Amendments to the Drawings:

REMARKS

The present Amendment is in response to the Examiner's Final Office Action mailed August 9, 2005. Claim 14 was previously cancelled, claims 1, 8 and 13 are amended. Claims 1-13 are now pending in view of the above amendments.

FIG. 2
~~Fig. 2~~

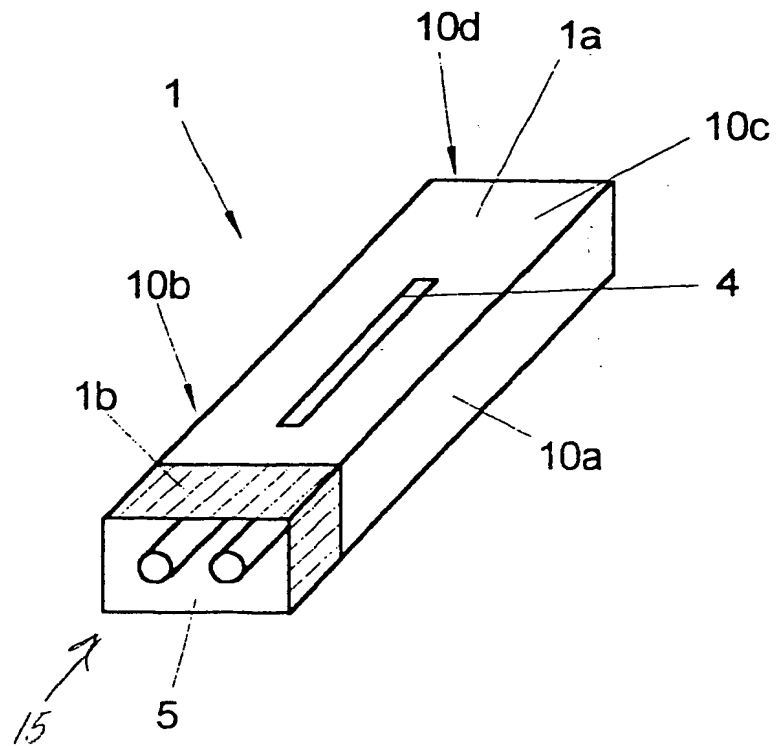
The attached sheets of drawings include changes to Figs. 2, 3, and 4. These sheets which include Figs. 1-4, replaces the original sheets including Figs. 1-4. In Figs. 2, 3, and 4, reference symbol "15" was added to indicate the optoelectronic component.

The Examiner has stated that the electrical component/transceiver must be shown or the feature cancelled from the claim. Figs. 2, 3, and 4 have been changed to include the reference numeral "15" directed to the optoelectronic component. Furthermore, the specification was amended to include the reference numeral "15". Therefore, the objection to the drawings by the Examiner is believed to have been overcome.
